Cascades Leisure Centre

GCLC-ASP-B1-XX-RP-A-08101-P02

Addendum to the Design and Access Statement
January 2026

SITE PLAN

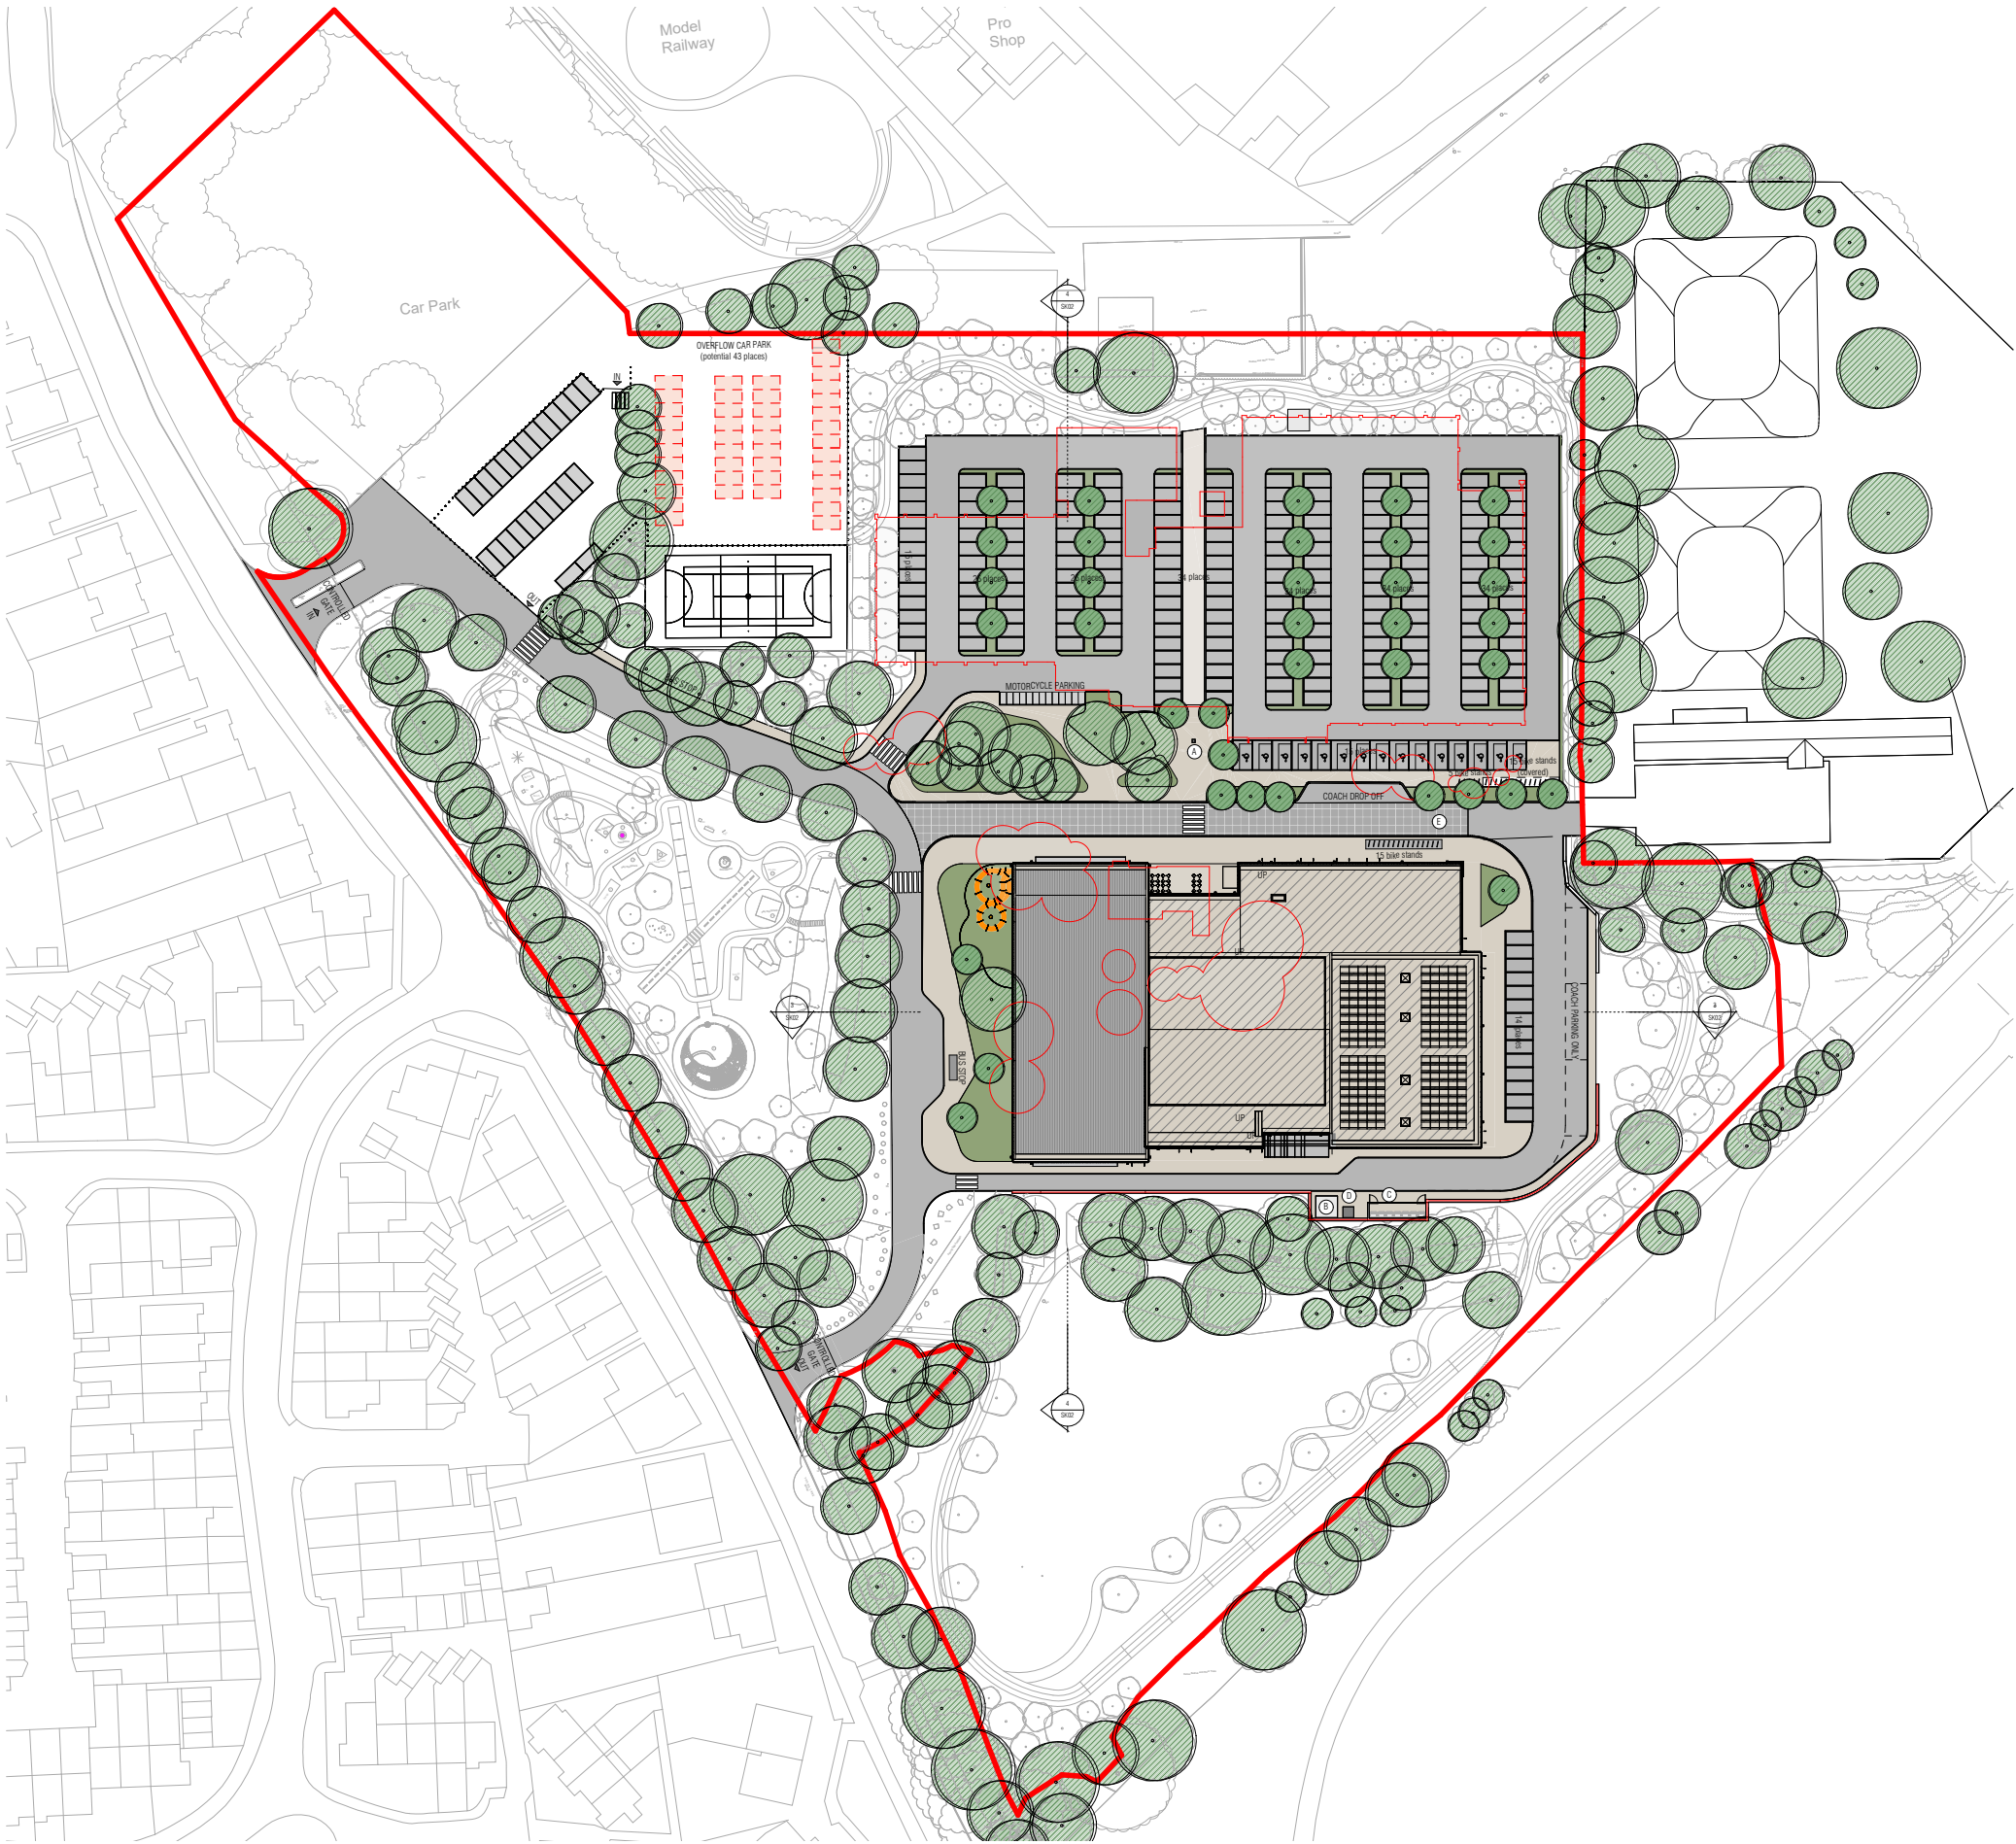
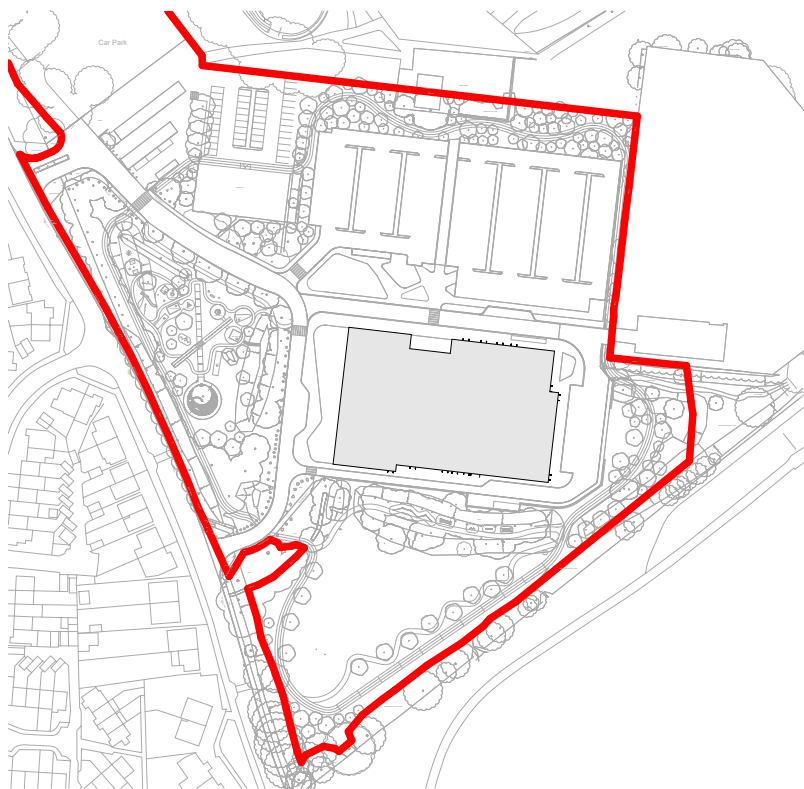
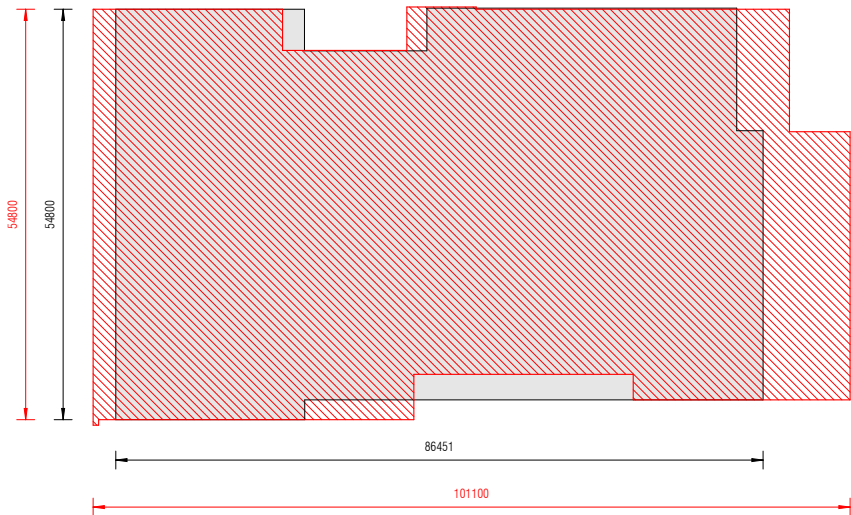
There is a reduction in GIFA from the approved scheme (7316sqm) to 6037sqm resulting in an overall reduction in footprint from the approved scheme (5,083 sqm) to 4,377 sqm in the varied scheme, (-706 sqm)

GROUND FLOOR PLAN

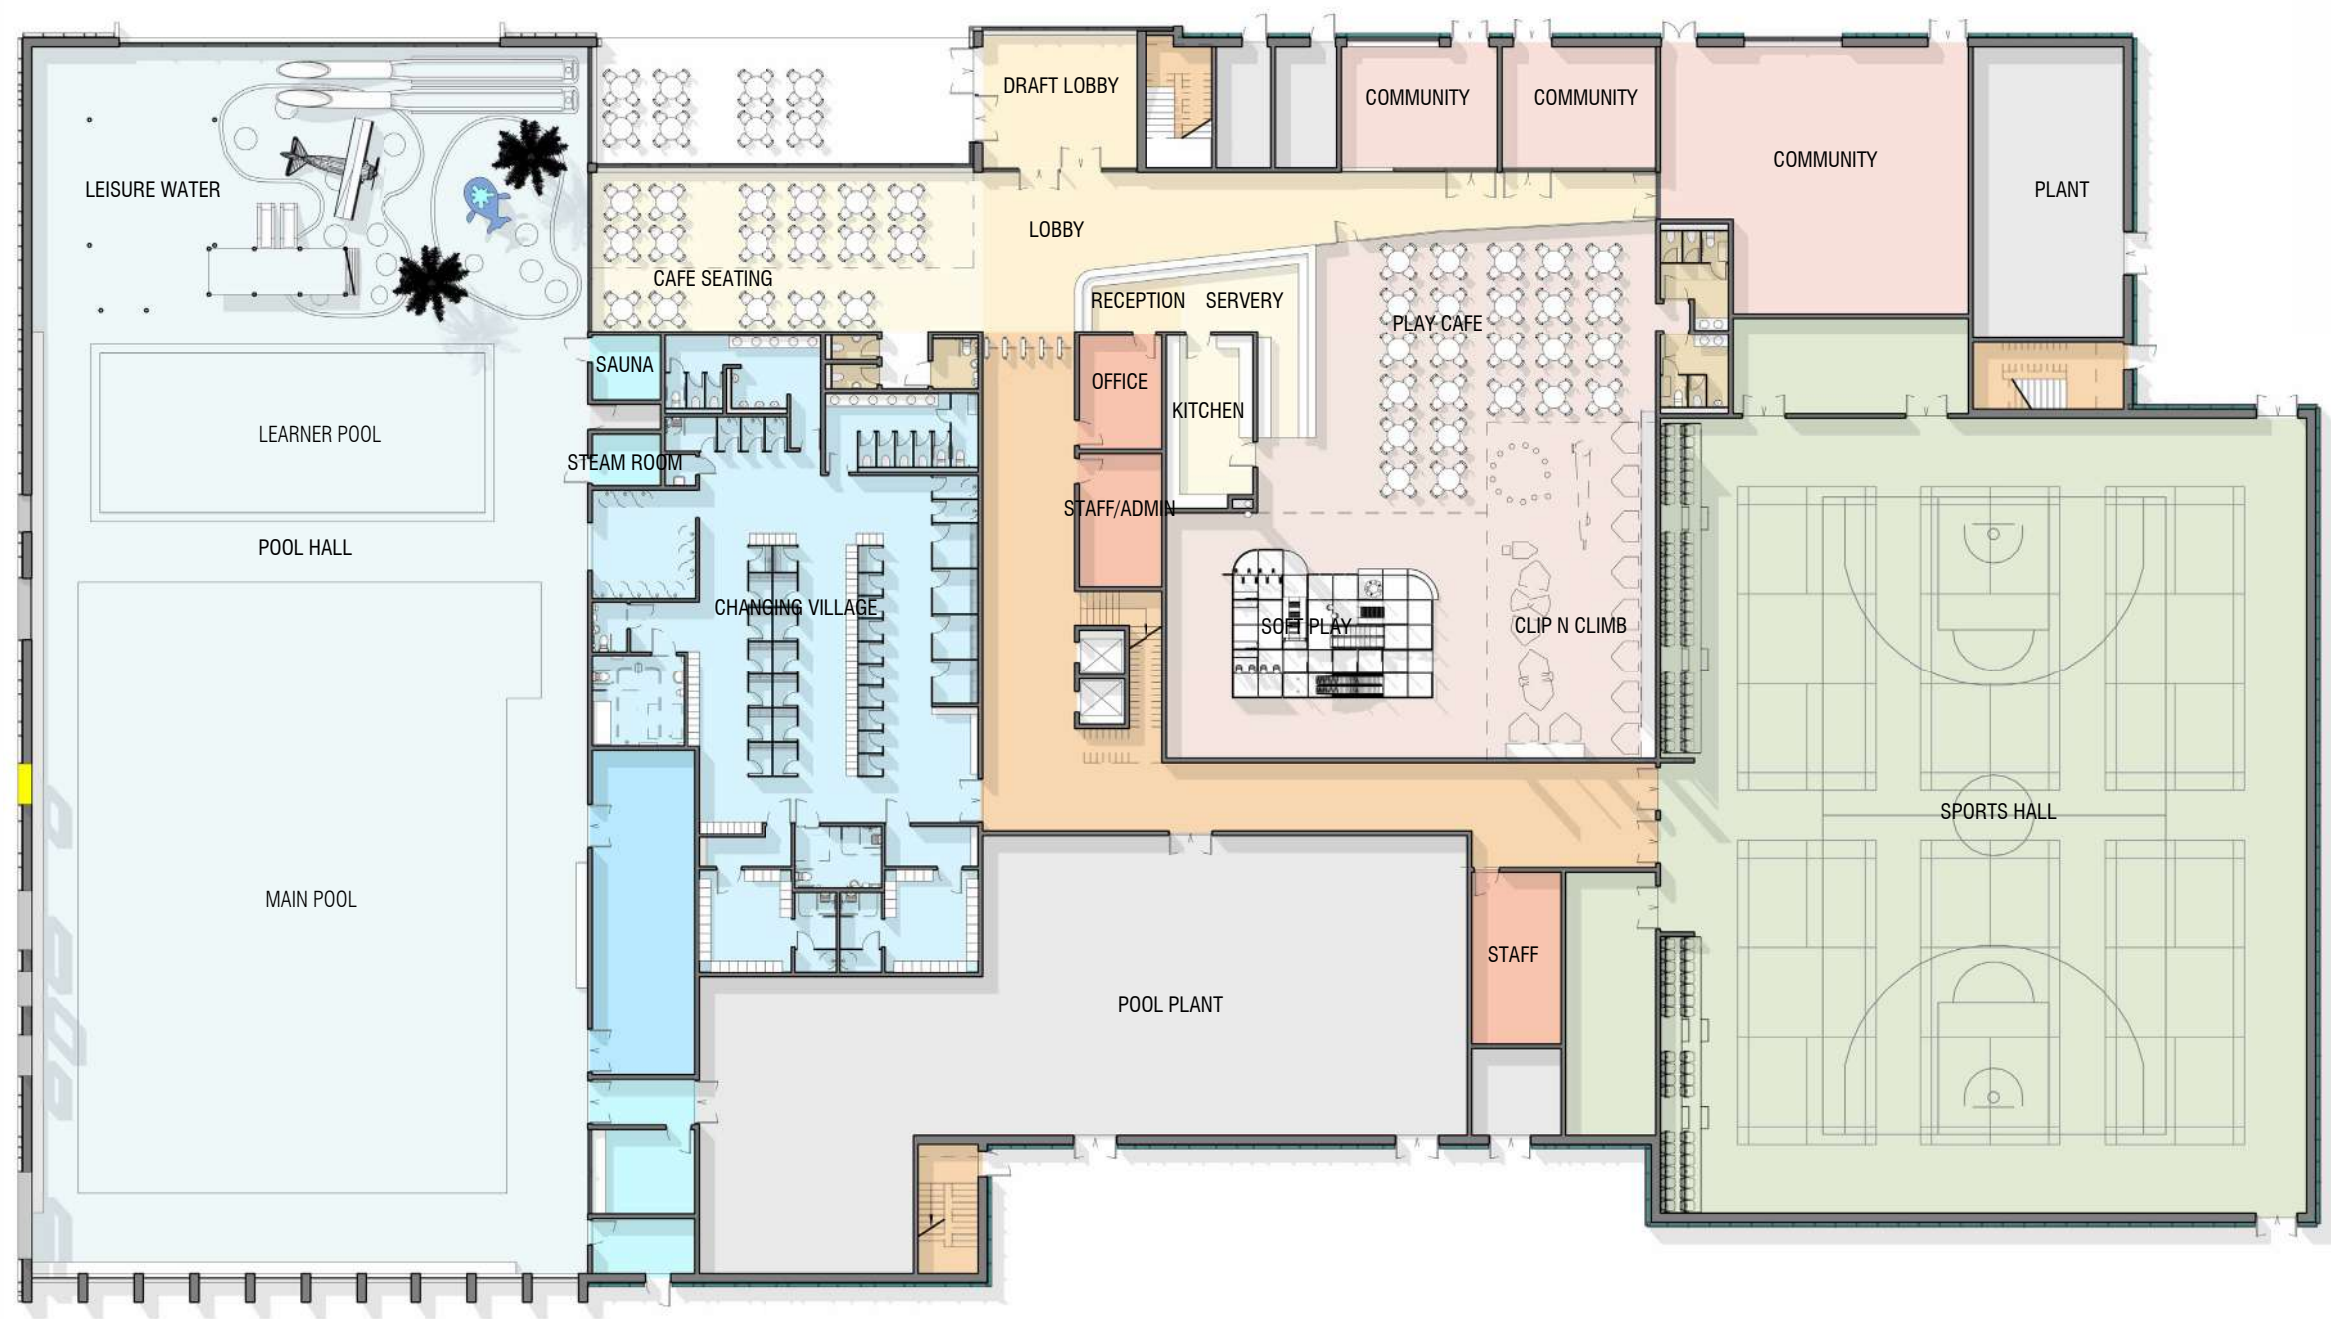
- Reconfiguration of the leisure water space to the north west of the floorplan with a reduction in dedicated floorspace of 306.43 sqm to 297.39 sqm. No reduction in overall offer and small reduction in space (total of 9.04 sqm).

- Slight reduction in pool hall of 1016.75 sqm to 996.35 sqm (20.4 sqm) size but no reduction in overall offer of a learner pool and main pool of eight lanes.

- Removal of sauna and steam room. (- 18.63 sqm)
- Removal of clip and climb from scheme (which is listed within the description of development). (-112.27 sqm)

- Due to the removal of the clip and climb, the children zone is retained and redesigned which results in the reconfiguration of the layout to the café seating/ play café and soft play. Larger play café space proposed in amended scheme (from 165.93 sqm to 175.62 sqm).

- Reduction in hub/reception area (from 160.92 sqm to 120.33 sqm). -40.59 sqm
- Removal of large community space to the north east side of the building (145.91 sqm). Overall reduction in community space from three separate spaces providing 215.71 sqm, to now providing two smaller spaces at 35.63 sqm and 36 sqm (overall provision of 71.63 sqm). This retains the service provision required in the Clients Brief and aligned with the project budget.

- Overall increase in sports hall storage and associated lobby area from 90.21 sqm to 116.39 sqm (+26.18 sqm). Six courts are still to be provided.
- Reduction of pool plant space from 435.38 sqm to 318.7 (-116.68 sqm).

- General reconfiguration of floorplan in terms of storage, office space, WCs to suit the new redesign.
- Omission of internal plant area adjacent to the large community room and 2 smaller plant rooms adjacent to entrance and next to sports hall in approved scheme (due to M&E strategy), (-126.7sqm)

- Reduction of viewing café to the leisure water, (- 34.8 sqm)
